**SAFETY
 RECALL**

Sr12-20

| SUBJECT : AUTOMATIC FIRE DETECTION AND SUPPRESSION SYSTEM (AFSS) - REROUTING LINEAR THERMAL DETECTOR (LTD) | |

Engine turbocompressor side

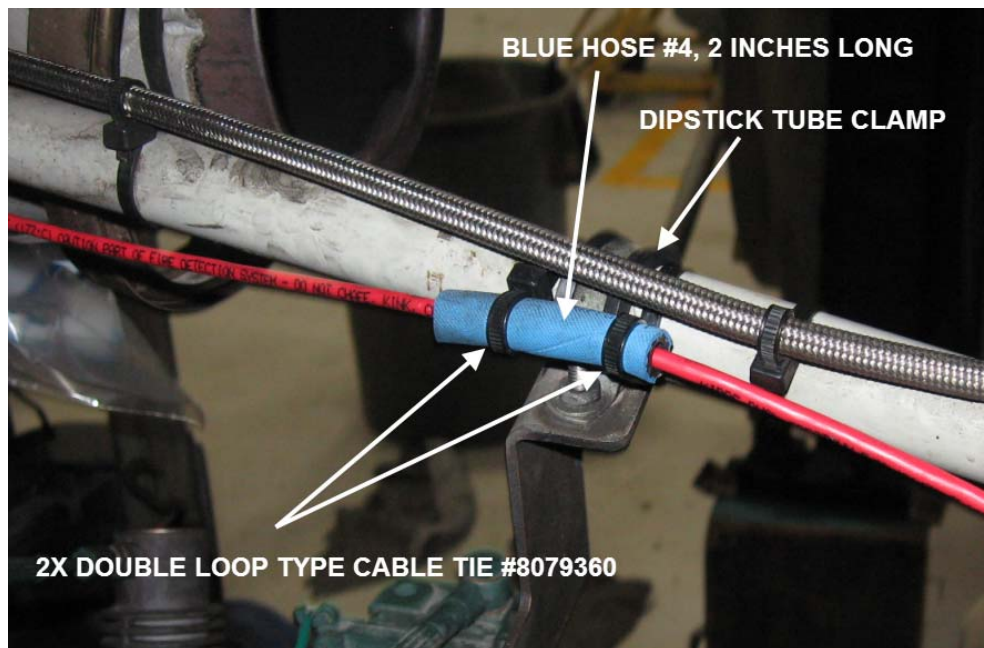
Rubbing of the linear thermal detector (red cable) against the clamp securing the Allison transmission oil level dipstick tube is likely to happen.

Protect the linear thermal detector (red cable) against the clamp securing as shown on the image below. Use a slit piece of 2 inches long (0.167 ft) blue hose #4 (p/n 503706). Use 1 double loop type cable tie (p/n 8079360) on both sides of the dipstick tube clamp.
